**RE: Corrective Measures Work Plan Addendum #2
Mineral Springs Road Former Manufactured Gas Plant Site**

NATIONAL FUELS GAS
 MINERAL SPRINGS ROAD FACILITY
 6025836.200

FIGURE: 3

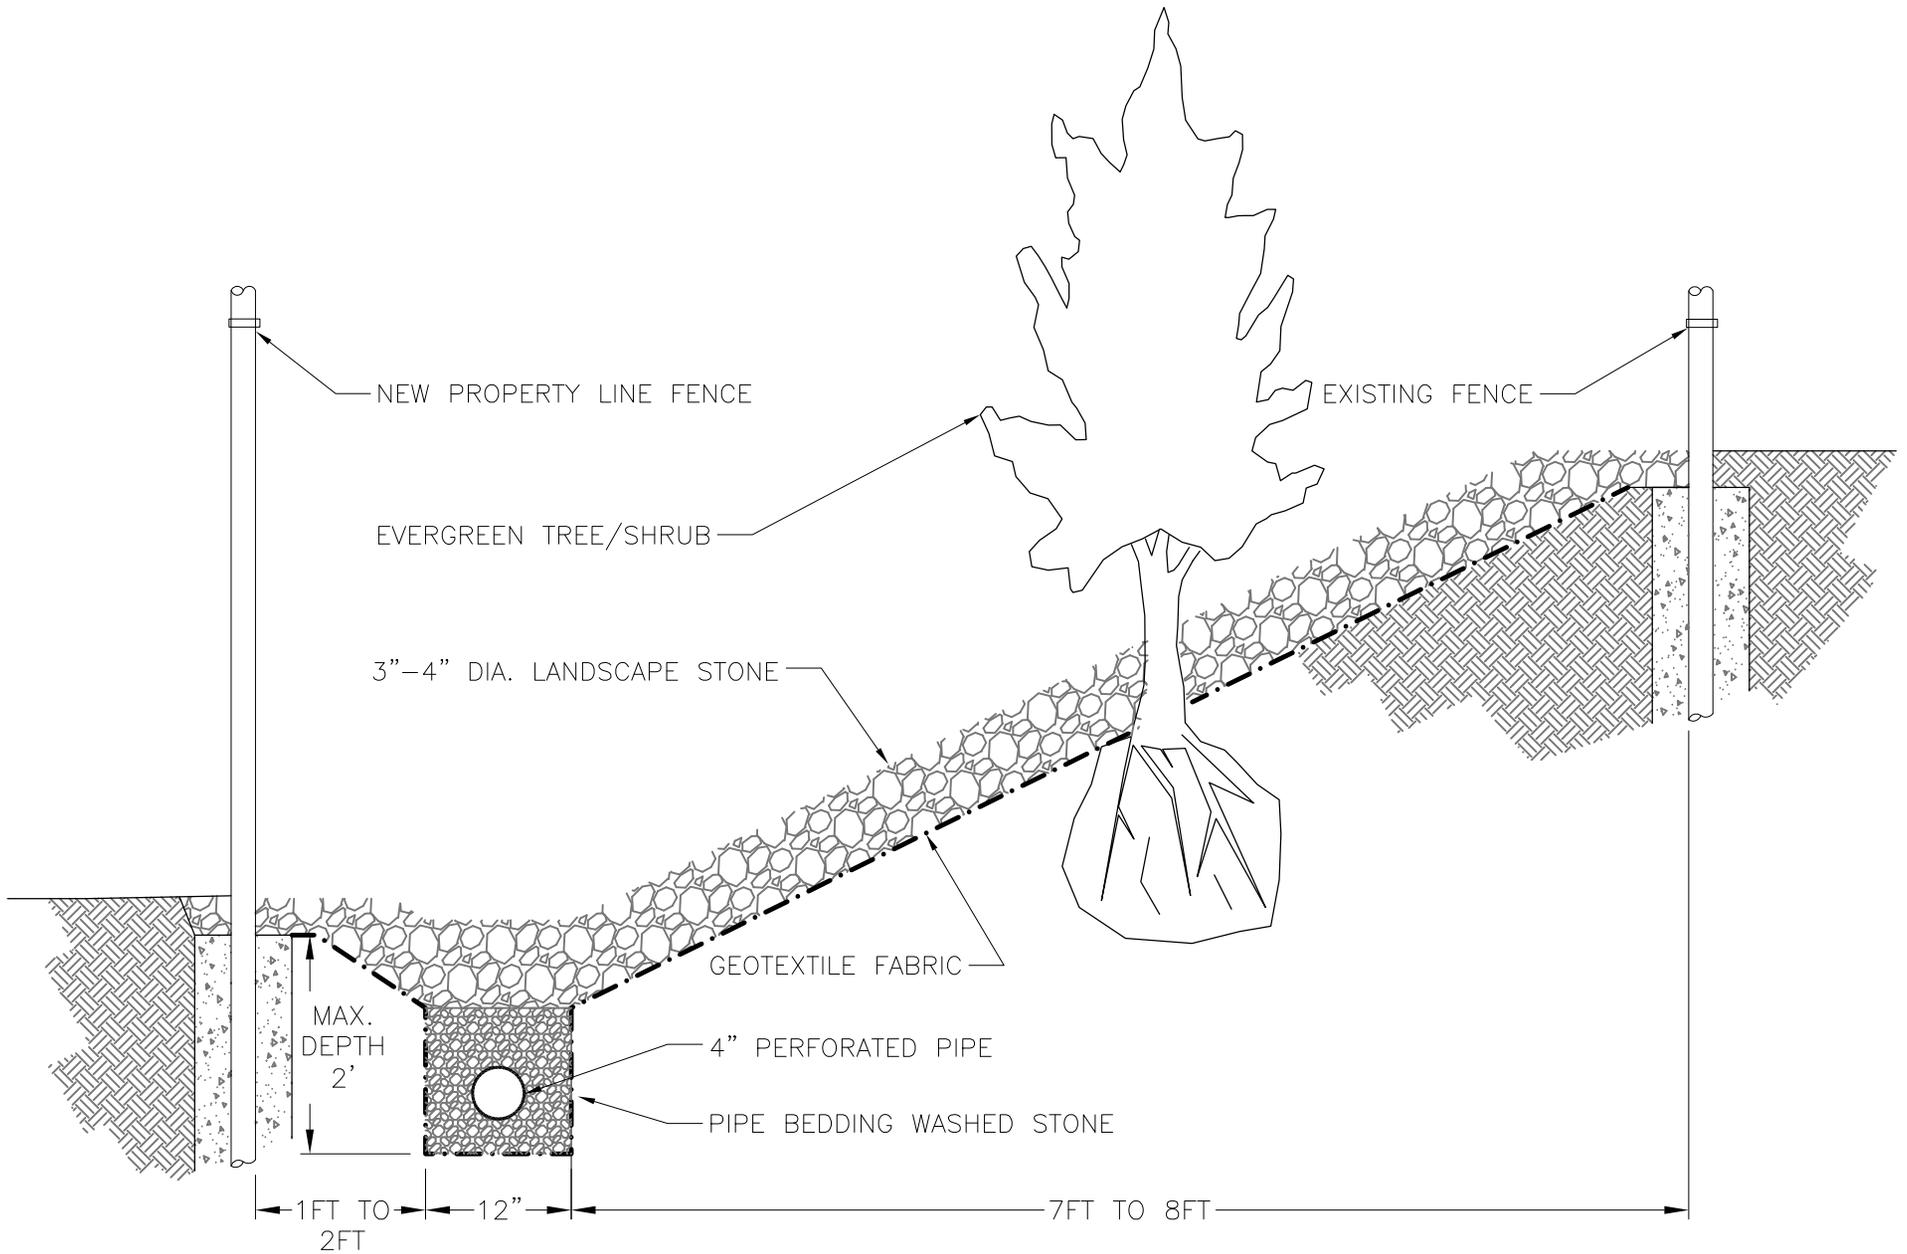
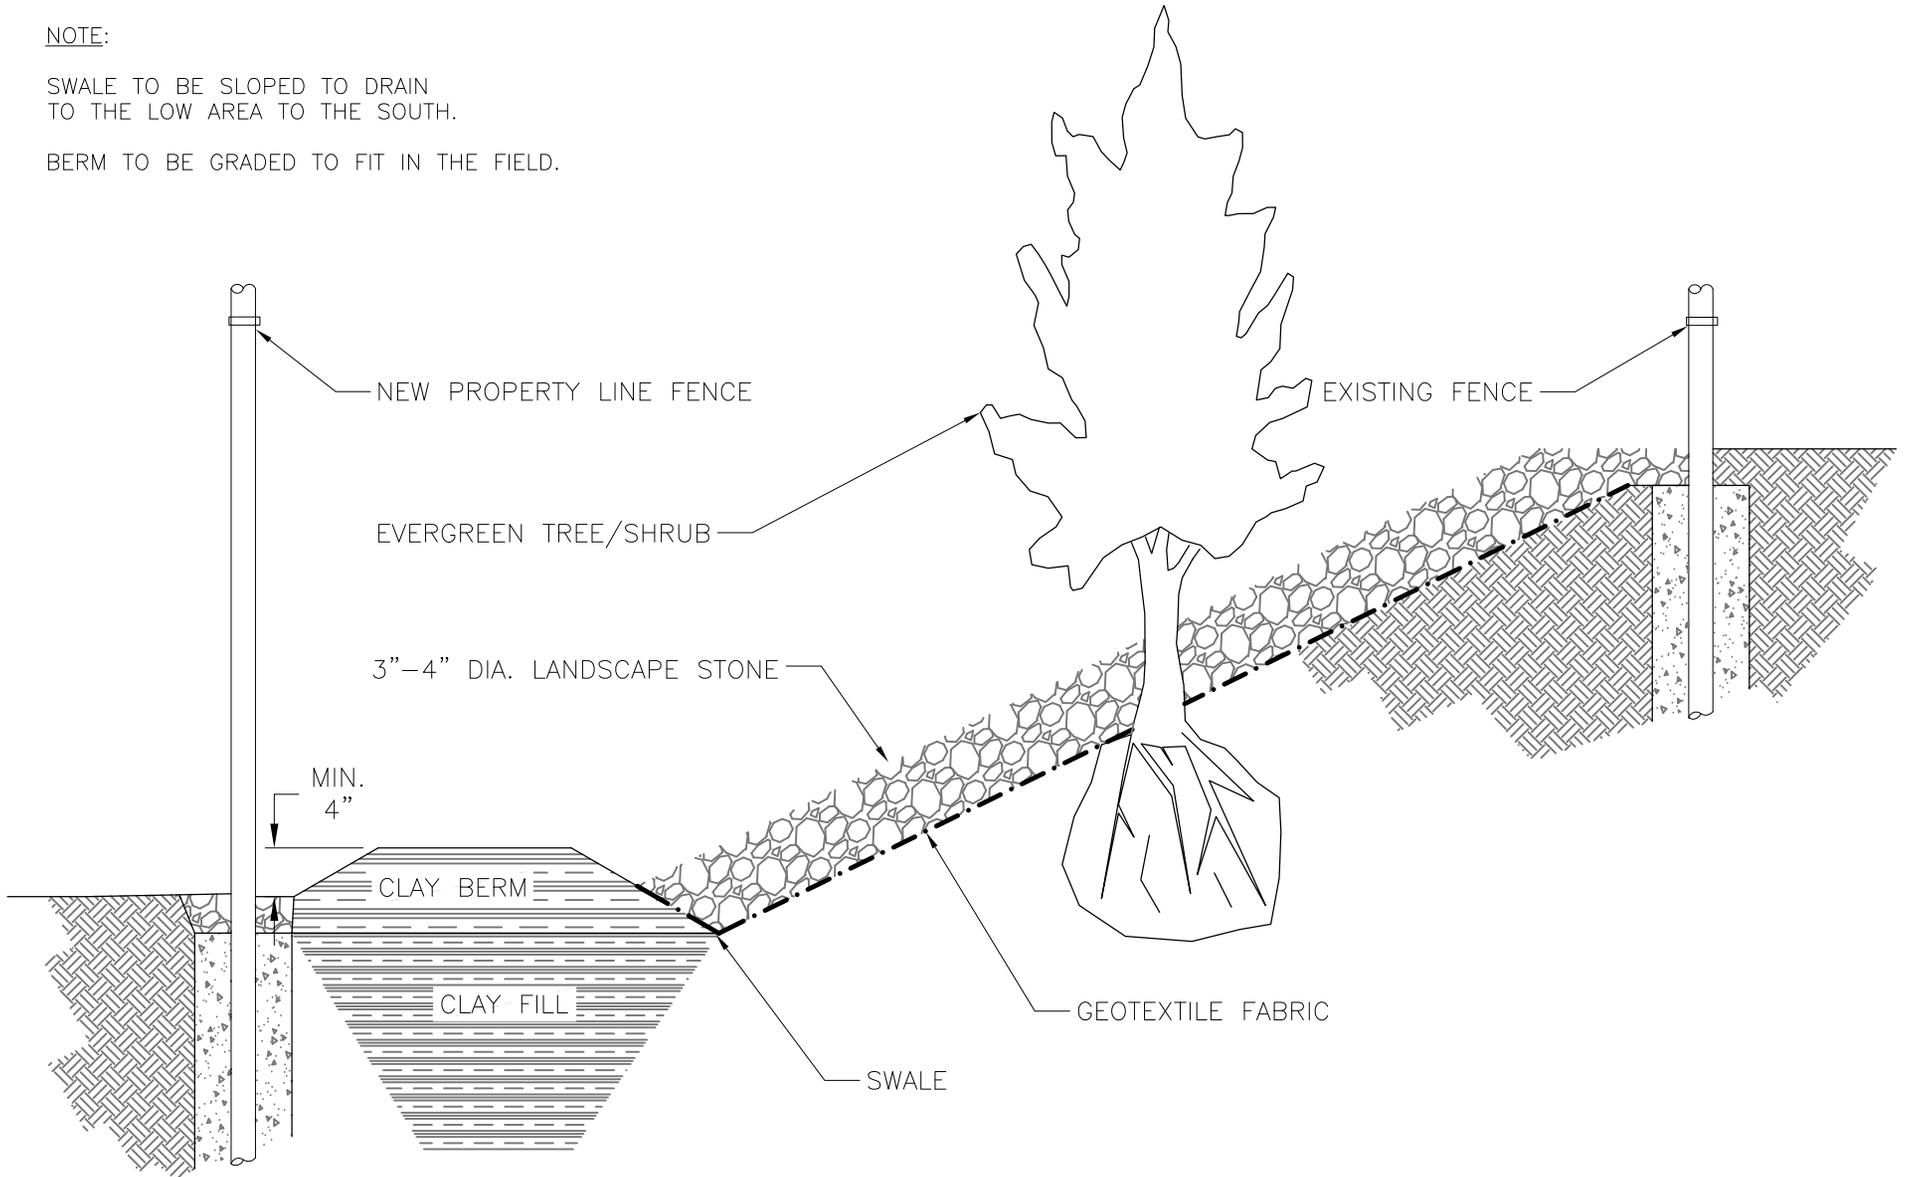
NFG proposes to revise the slope cross-section as shown in Figure 3. This is consistent with the intent of the original design, since it will address surface water and not perched groundwater. The swale created by the berm will be sloped so that surface water drains toward the low area on the southern end of the property.

SWALE TO BE SLOPED TO DRAIN TO THE LOW AREA TO THE SOUTH.

BERM TO BE GRADED TO FIT IN THE FIELD.

MINERAL SPRINGS ROAD FACILITY NATIONAL FUEL GAS 60250836.300		PROPOSED CORRECTIVE MEASURE
DATE: 08/20/2013	DRWN: BcV	FIGURE 2

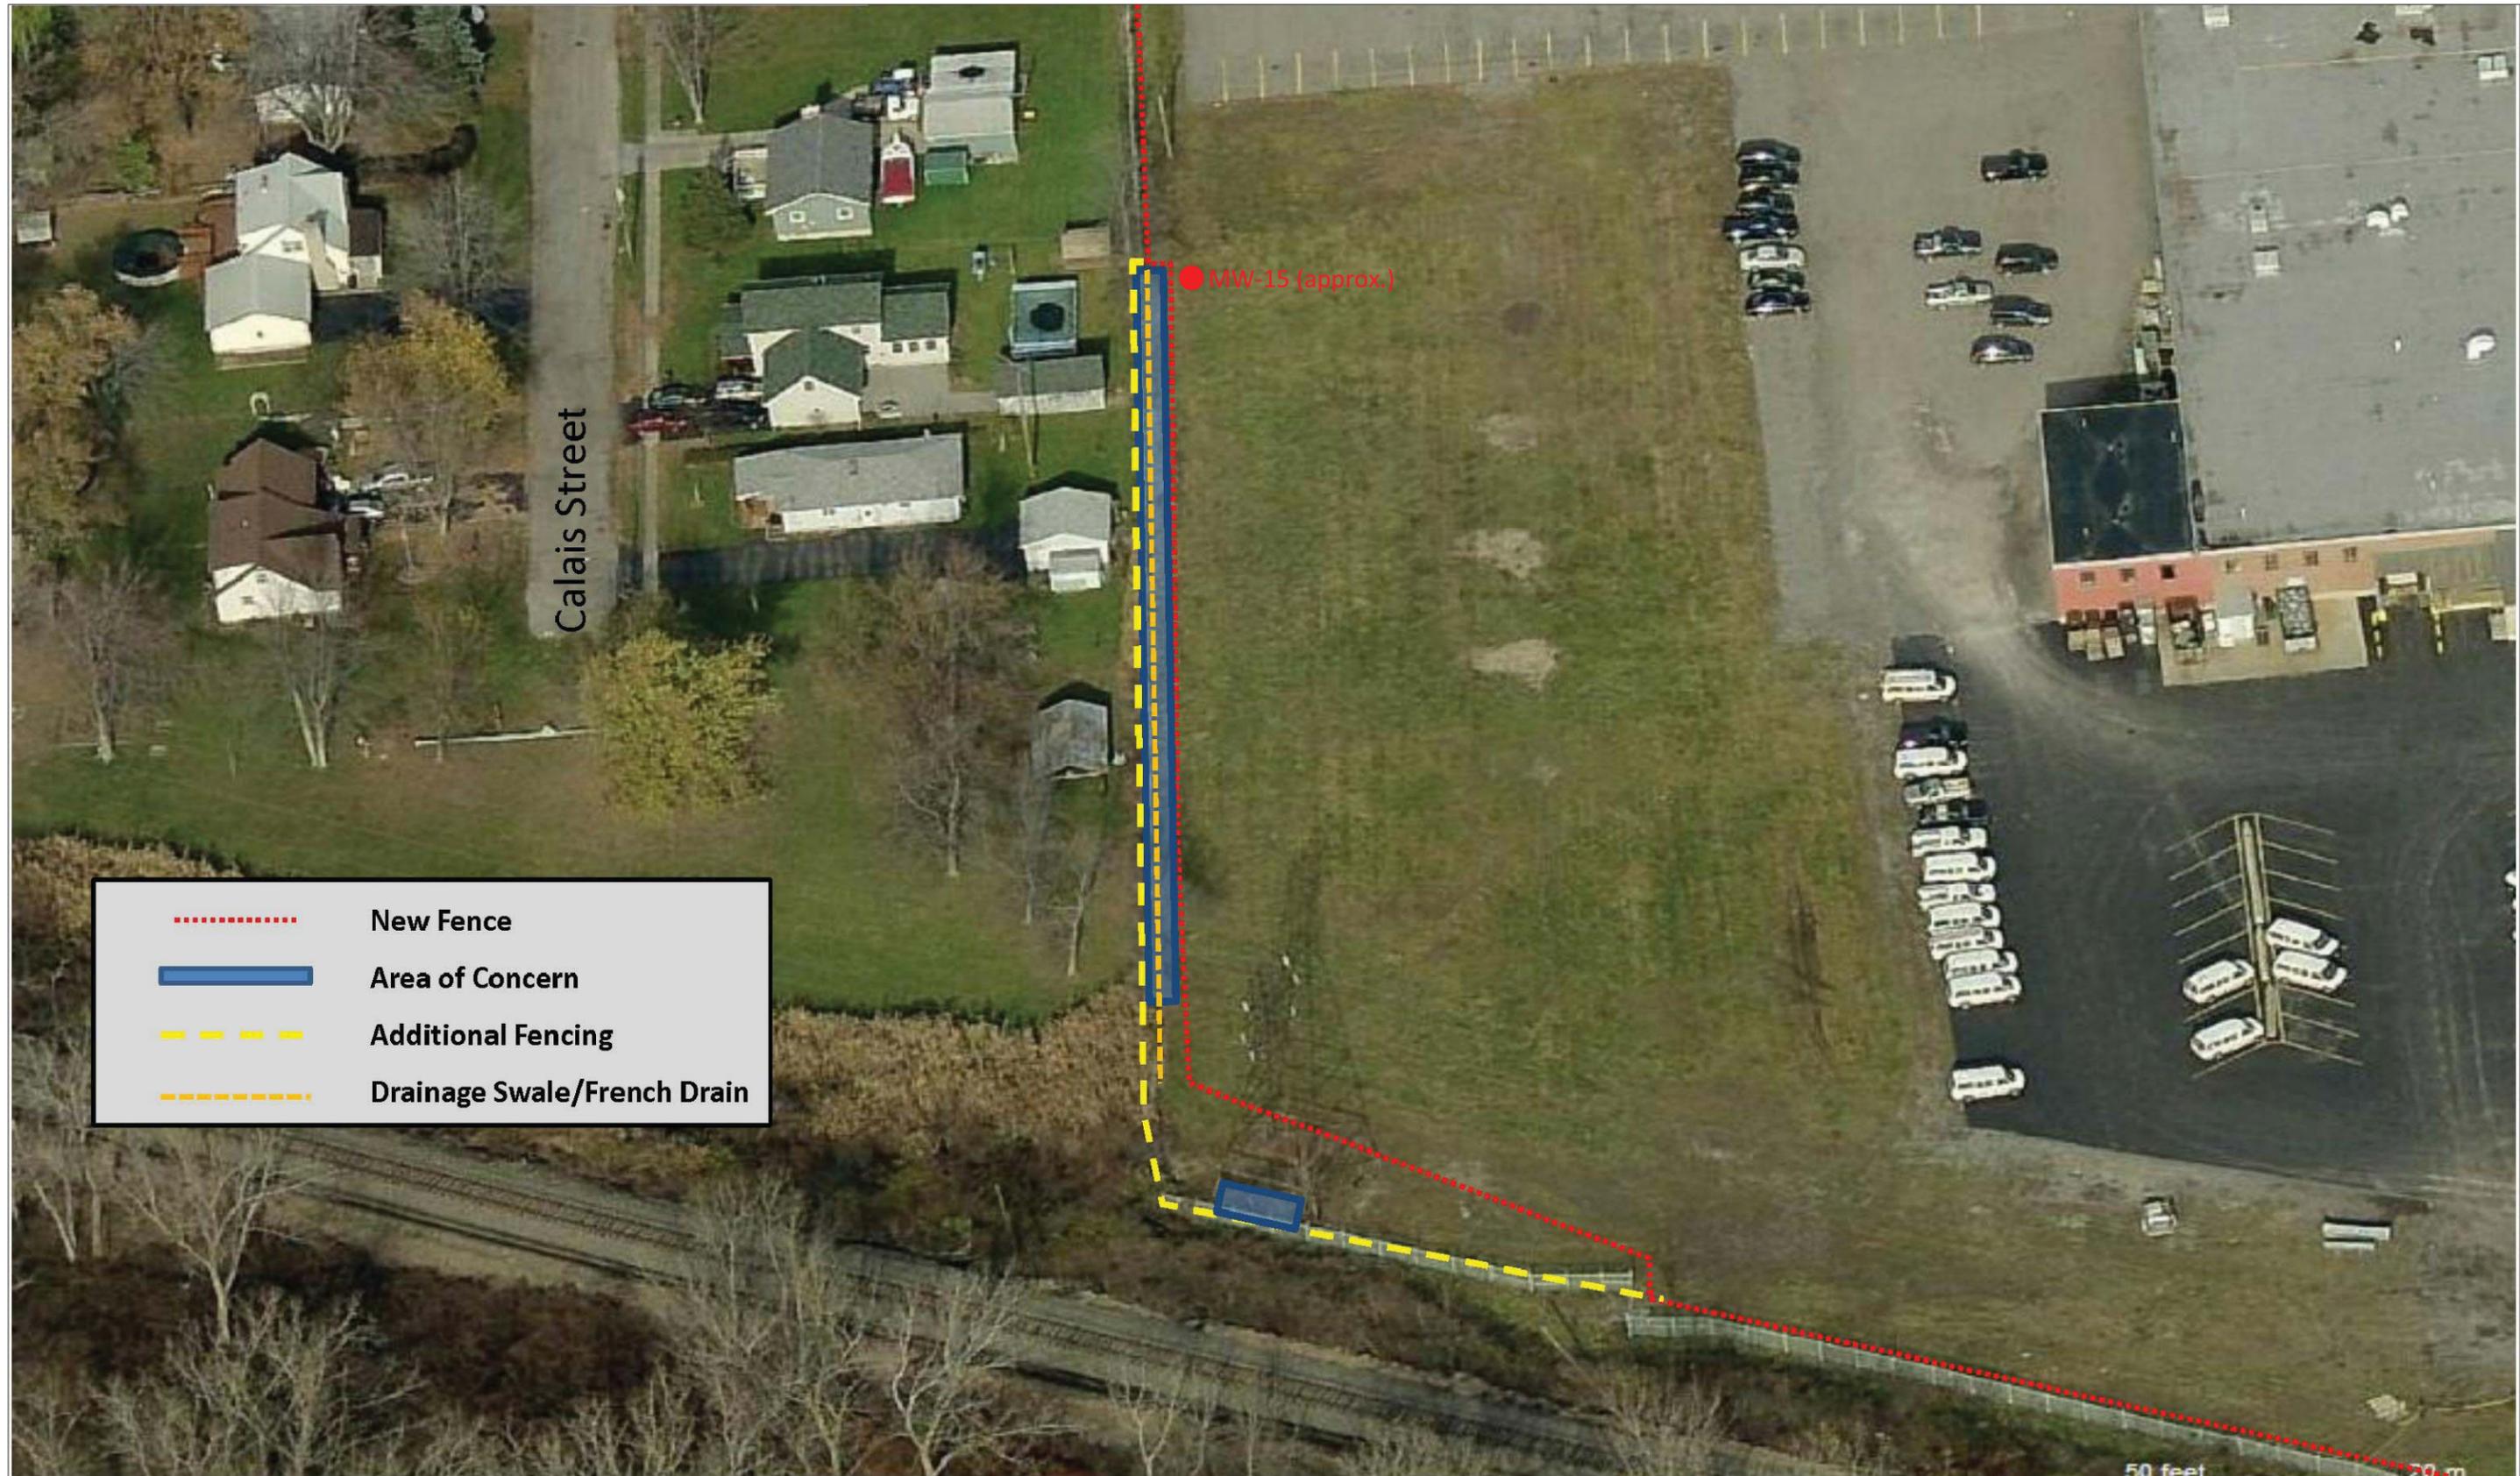
Figure 1 shows the planned ditch cross-section from the September 26, 2013 CMWP. AECOM reviewed the boring log for well MW-15, which is next to the excavation area, as shown on Figure 2. The well log is also attached with a mark showing the approximate trench bottom depth. This was estimated based on the recently completed survey. A review of groundwater elevations from MW-15 measured since 1997 shows that the depth to groundwater has never been shallower than 7.95 feet. This elevation is shown on the log. Based on this information, the source of the water in the ditch appears to be a perched ground water table which collects beneath a fill layer and above a naturally occurring clay layer.
